# Comments on the Proposed Access to serve the Development at Foxhole Farm

John Bailey  
2 December 2022

Foxhole Lane, Bolney: Further Transport Information

Project No:ITB16634-005

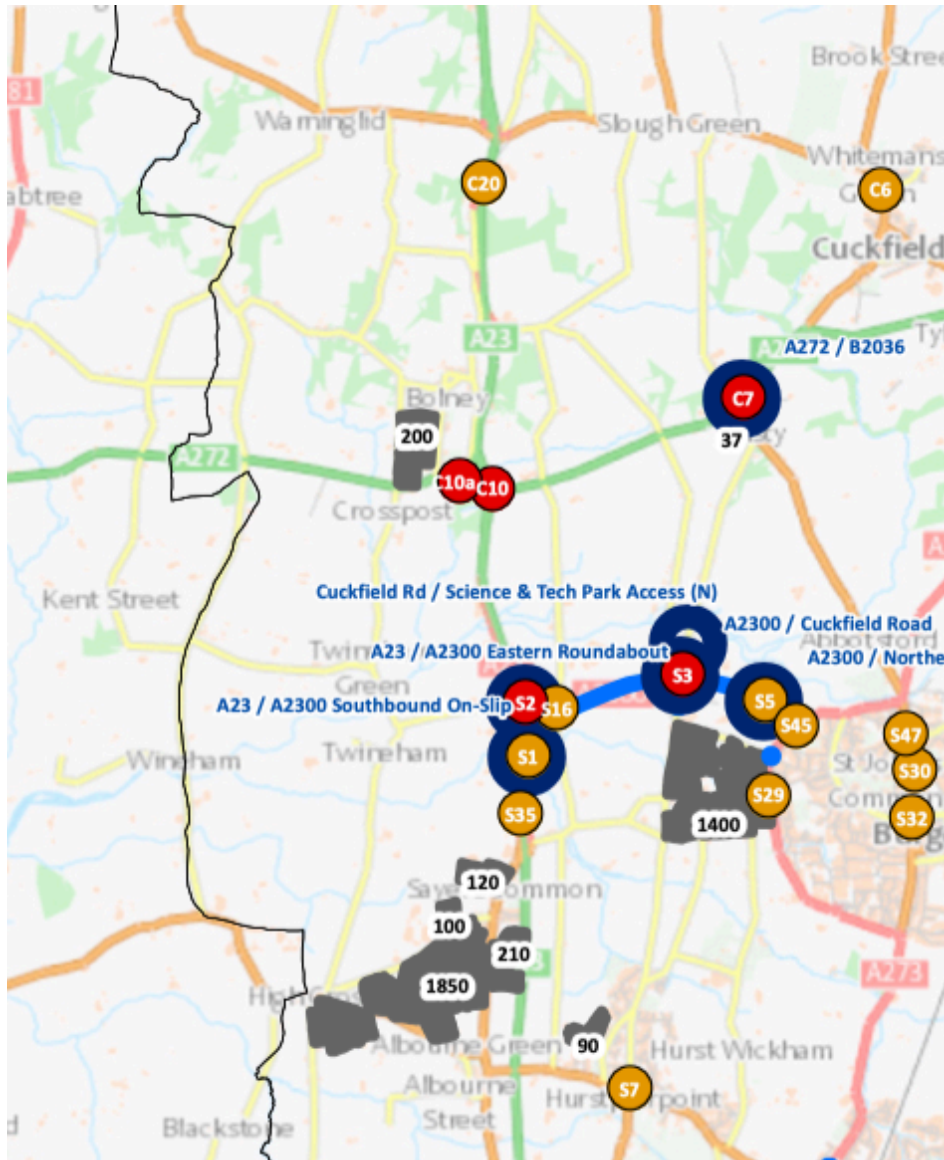
In layman's terms this means a road has a design capacity of a certain number of vehicles per hour. When the flow reaches 100% of the design capacity, significant congestion occurs

The projected flows detailed in the report state that the RFC exceeds the 100% mark on several approaches during AM and PM periods. Again in terms we can all understand , RFC above 100% is traffic saturation .

This could cause potential congestion on the northbound off slip of the A23 as traffic is stacking unable to gain access to the A272. A worse case safety scenario is queuing traffic on Lane 1 of the Northbound A23 , with the potential for rear end collisions .
